Sanitary Survey Report

**Polacca, Arizona
PWSID #0400106**

Survey Conducted on April 7, 2014

**Sanitary Survey Conducted by
Dan L. Fraser, PE and JanDee May
Sleeping Giant Environmental Consultants, LLP**

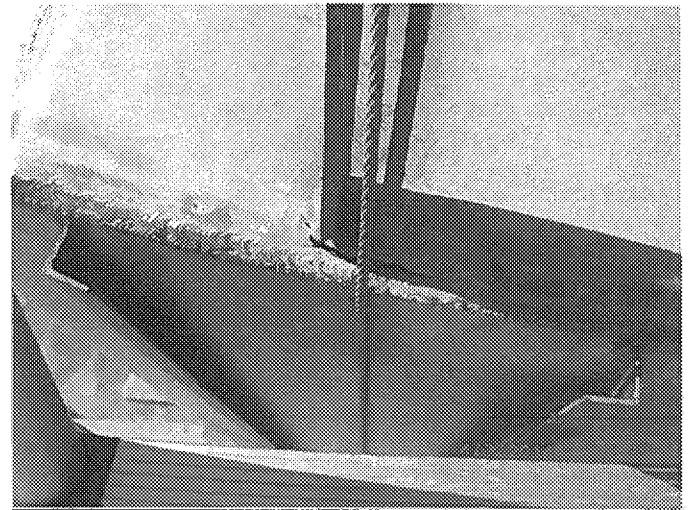
Comments: The mesa tank has not been cleaned for a long time. It is in poor condition and is leaking at its base. A cursory investigation would lead one to believe that replacement of the tank is in order. Pumping to the tank from the distribution system is manually controlled and leads to overflowing water regularly and running out of water occasionally. The latter problem subjects the upper mesa distribution system to pressure loss and risk of contamination. The tank is to be replaced in 2014.

The two photos above are nearly identical to the two included in the 2010 sanitary survey report. No attempt has been made to correct these deficiencies. Clearly, the tank needs to be replaced; however, with just a little effort, improvements could be made to correct these kinds of sanitary deficiencies. Simple addition of silicone caulking would keep insects and dust from entering the tank through the openings shown in the lower photo.

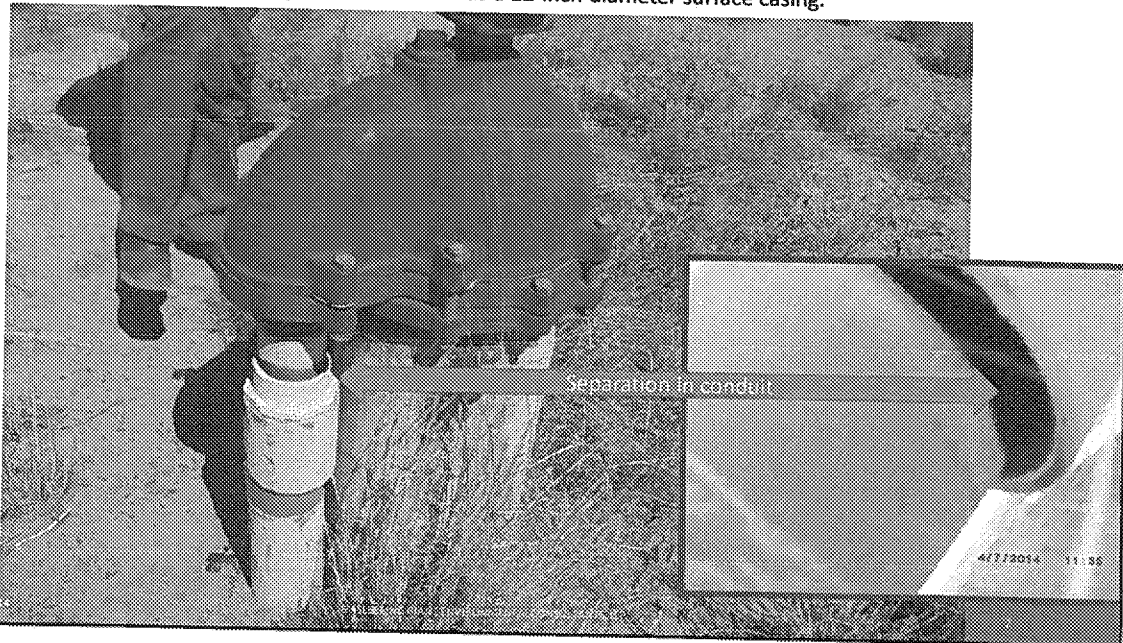
GW002/West Well 6: This well is the only one in service on the west side of the PWS. It produces about 130 gpm. The sanitary seal is vented and screened but the conduit is separated. The opening offers opportunities for insects, spiders and dust to enter the casing. The well does not have a security fence. The well has a 12-inch diameter surface casing.

GW003/West Well 5: This well also has a 12-inch diameter surface casing. It has been offline for years. It reportedly has a new pump but doesn't produce water. There appears to be disagreement about the cause of the problem and apparently not a lot of interest in figuring it out and making corrections. The area around the casing is poorly graded offering an opportunity for water to pool and migrate down the casing

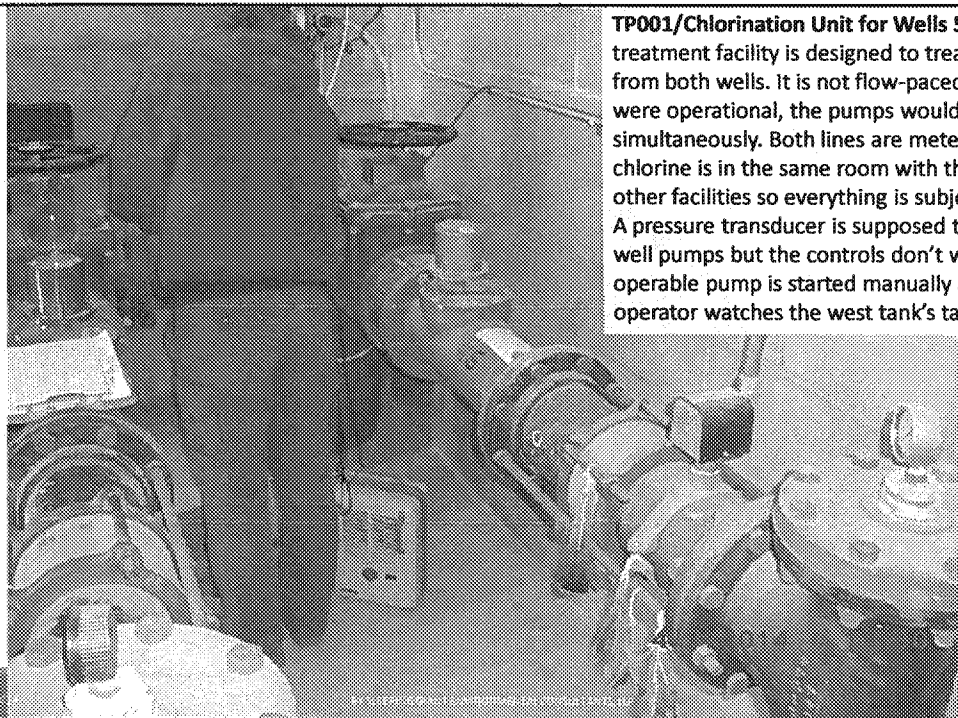
TP001/Chlorination Unit for Wells 5 and 6: This treatment facility is designed to treat the water from both wells. It is not flow-paced so if both wells were operational, the pumps would have to run simultaneously. Both lines are metered. The chlorine is in the same room with the controls and other facilities so everything is subject to corrosion. A pressure transducer is supposed to control the well pumps but the controls don't work so the operable pump is started manually and the operator watches the west tank's target.

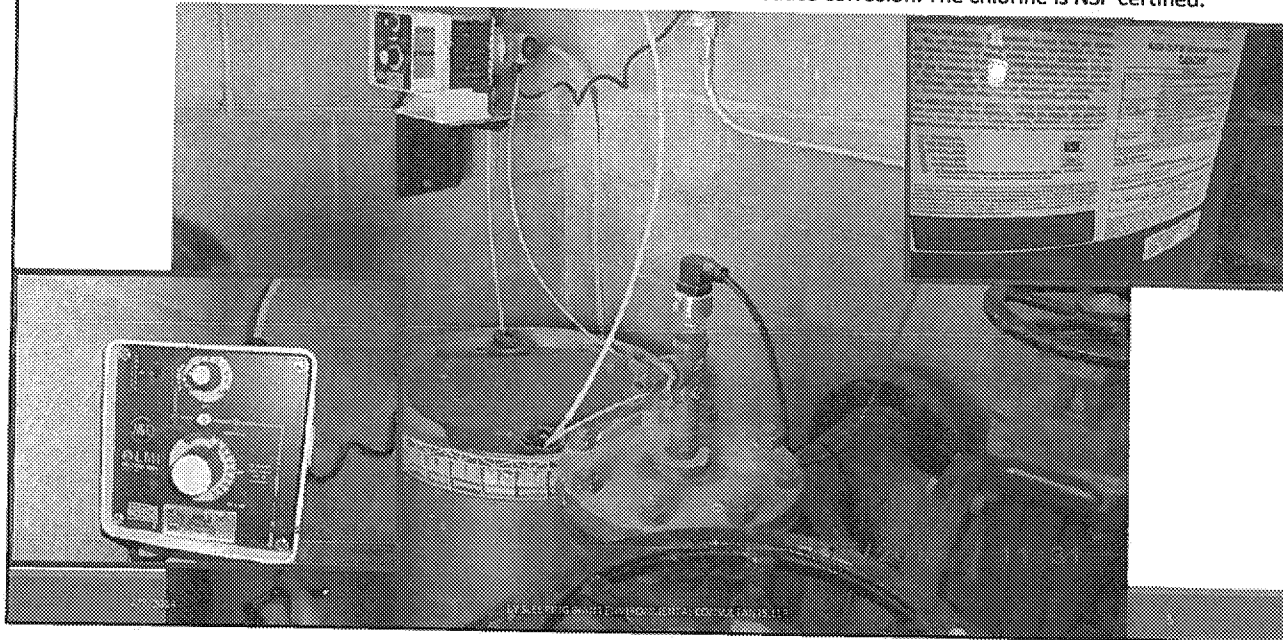
TP001/Chlorination Unit for Wells 5 and 6: The LMI metering pump is set at 20% stroke and 20% speed. This would lead one to believe it is oversized or the chlorine solution should be diluted. The pumps should run in their midrange to function best (per Milton Roy). The vat of chlorine is not sealed and vented to the exterior to reduce corrosion. The chlorine is NSF-certified.

ST001/Older West Storage Tank: Note the corrosion and that the hatch cover gasket has not been replaced for years.

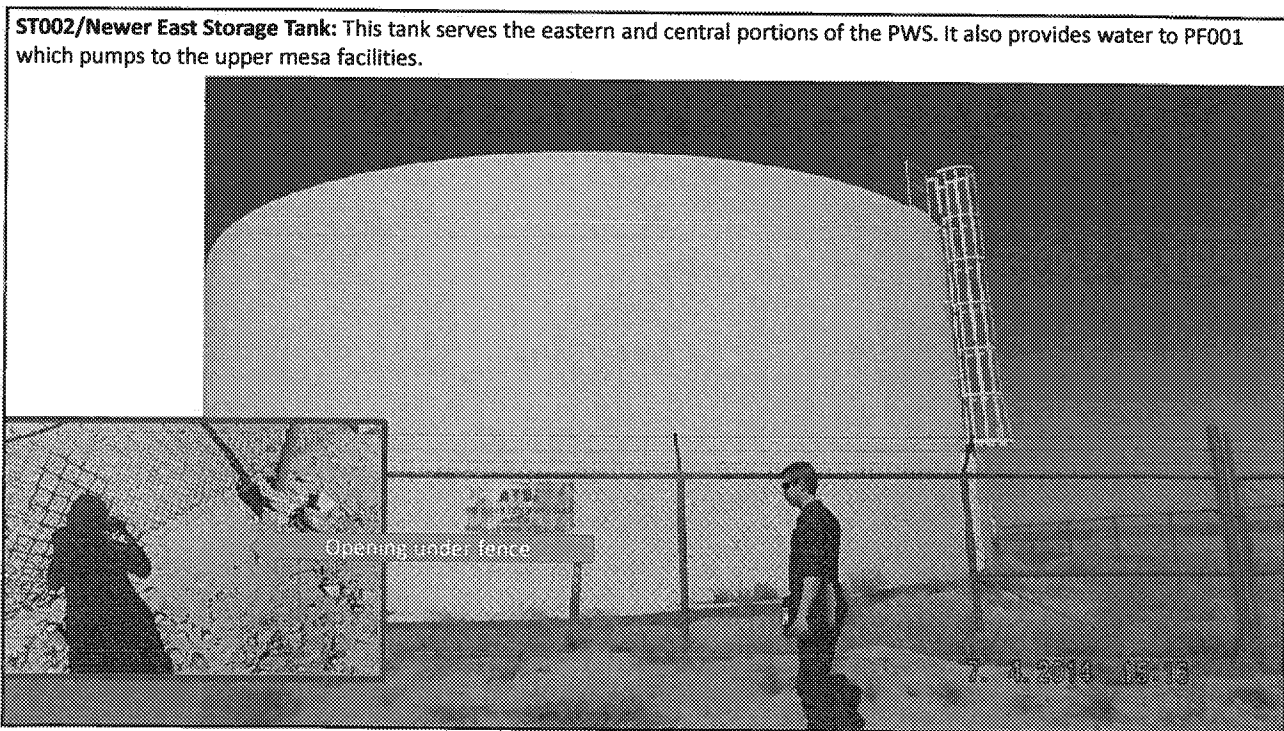
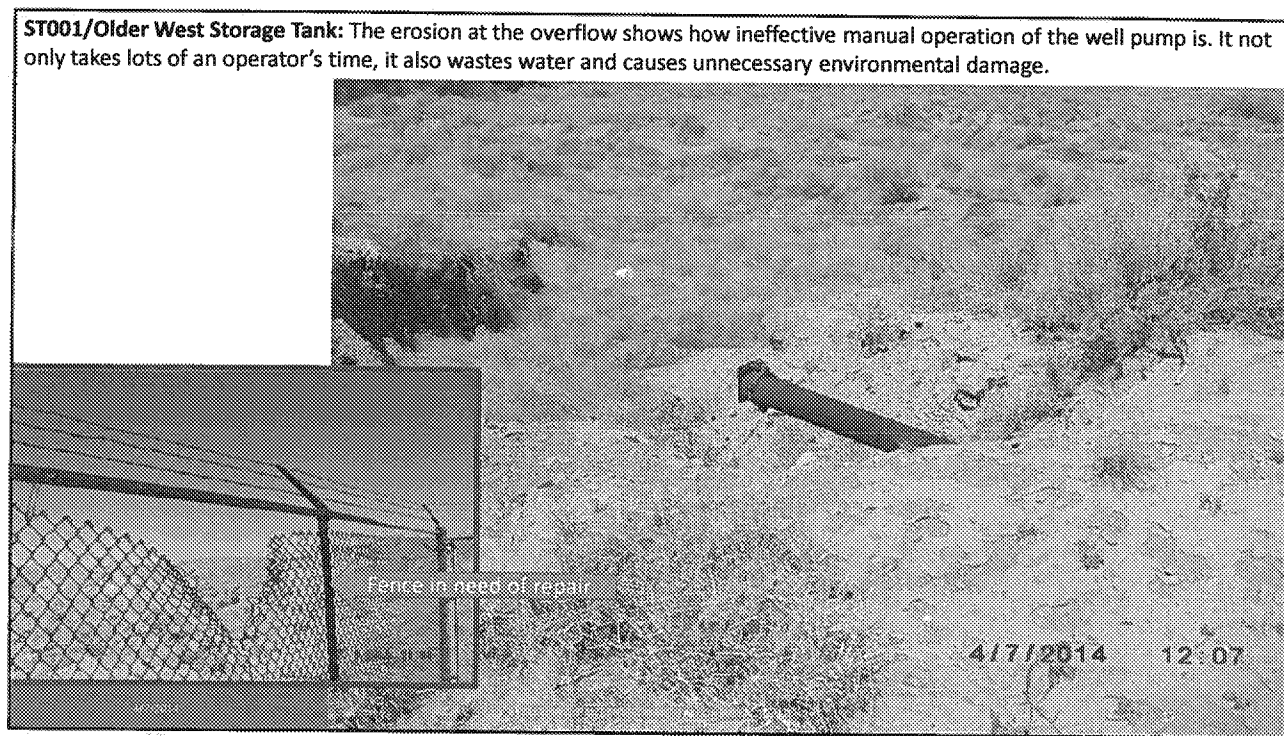
ST001/Older West Storage Tank: Additional signs of long term neglect.

ST001/Older West Storage Tank: The tank needs immediate attention. It should be taken offline and rehabilitated.

ST002/Newer East Storage Tank: The roof supports show the beginning of corrosion.

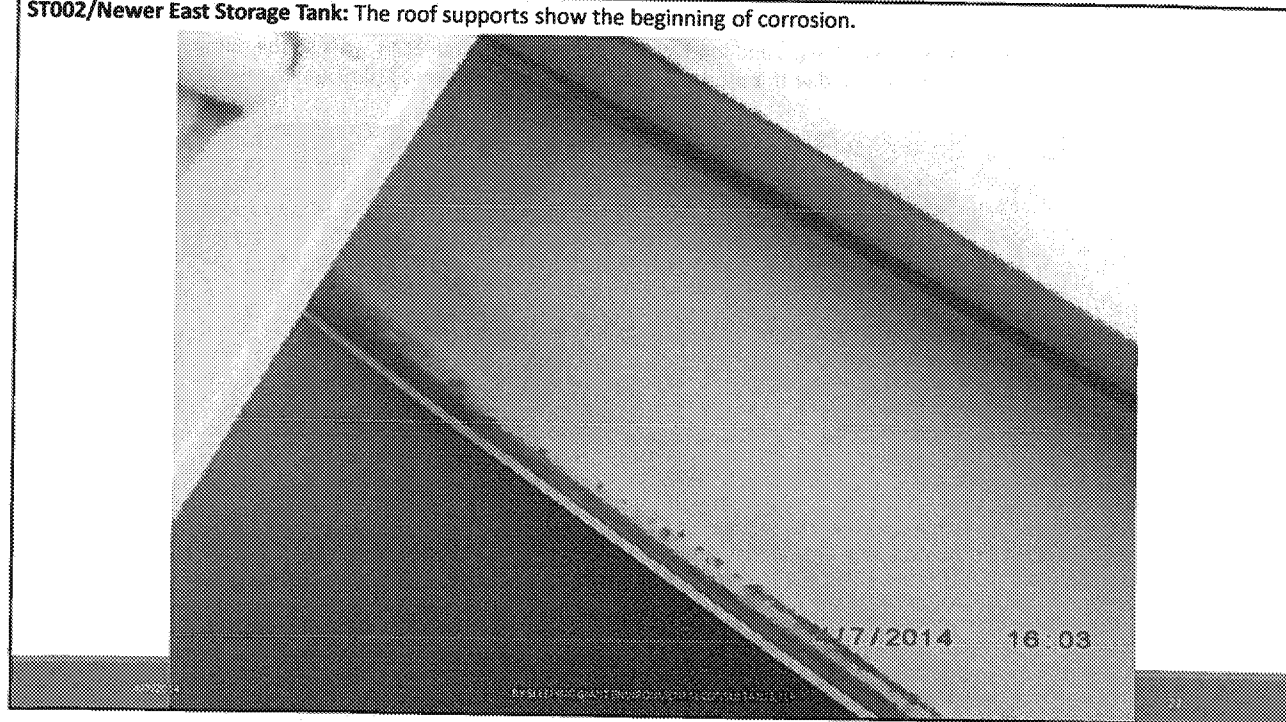
ST002/Newer East Storage Tank: Note the erosion that results from operating the system manually. The overflow is screened.

ST003/Upper Mesa Storage Tank: This is an opening caused by corrosion.

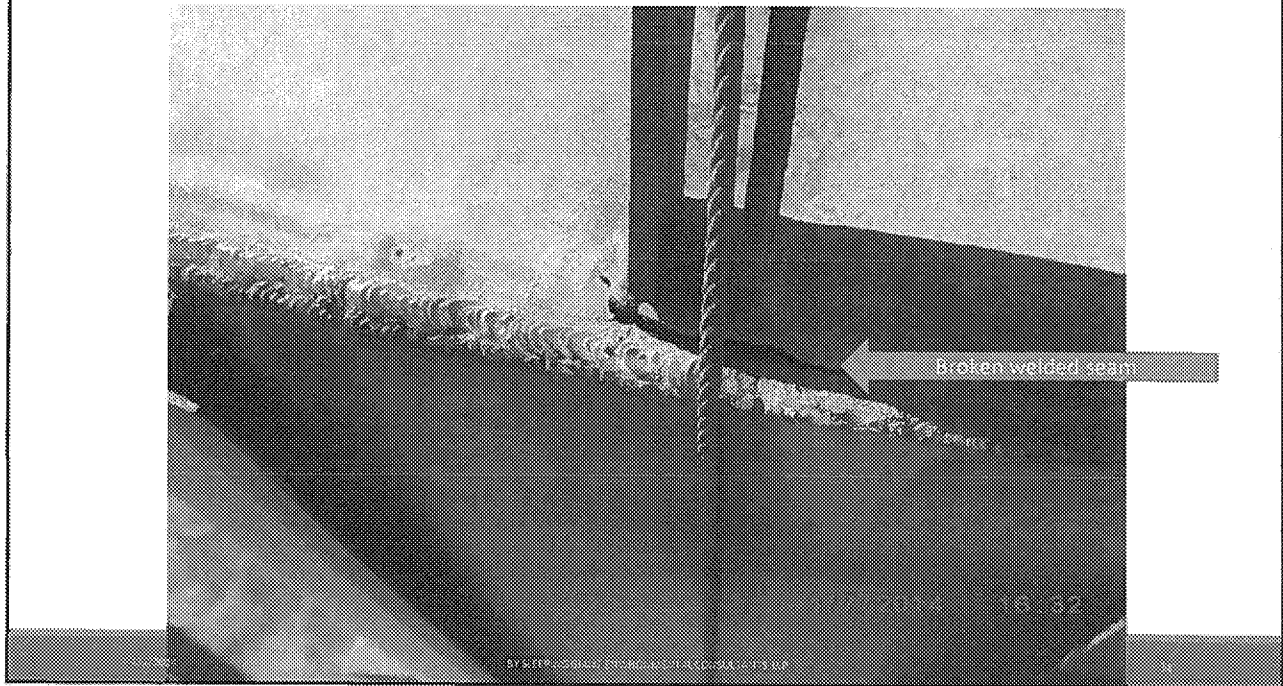
ST003/Upper Mesa Storage Tank: The inlet line leaks due to corrosion.
